<b>Product / Process Change Notification (PCN)</b>	
<input type="checkbox"/> Major Change <input checked="" type="checkbox"/> Minor Change	
<b>PCN Number:</b> PCN_ConCARD_20241112  <b>Affected Series:</b> WR-CRD  <b>Affected Order Codes:</b> 693063010911 693063020911  <b>PCN Date:</b> 2024-08-12 (YYYY-MM-DD)  <b>Effective Date:</b> 2024-11-12 (YYYY-MM-DD)	<b>Change Category:</b> <input type="checkbox"/> Equipment/Location <input checked="" type="checkbox"/> General Data <input type="checkbox"/> Material <input type="checkbox"/> Process <input checked="" type="checkbox"/> Product Design <input type="checkbox"/> Shipping/Packaging <input type="checkbox"/> Supplier <input type="checkbox"/> Software
<b>Contact:</b> Product Management  <b>Phone:</b> +49 (0) 7942 - 945 5001  <b>Fax:</b> +49 (0) 7942 - 945 5179  <b>E-Mail:</b> pcn.eican@we-online.com	<b>Datasheet Change:</b> <input checked="" type="checkbox"/> Yes <input type="checkbox"/> No  <b>Attachment:</b> <input type="checkbox"/> Yes <input checked="" type="checkbox"/> No

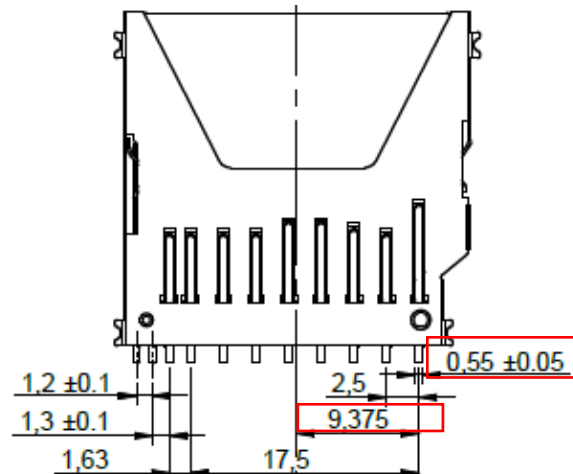
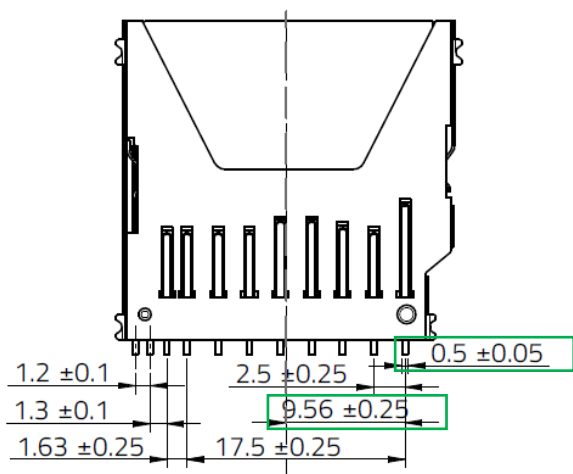
<b>Description of Change:</b> <p>As a datasheet information amendment, Würth Elektronik eiSos is adjusting the drawing of those two parts to better reflect the reality.</p> <p>This is a datasheet correction only. There will be no change in form, fit, function, quality or reliability of the product.</p>	
<b>Details of Change:</b>	
<div style="text-align: center; color: red; font-weight: bold;">Before Change</div> <p>693063010911</p> 	<div style="text-align: center; color: green; font-weight: bold;">After Change</div> <p>693063010911</p>
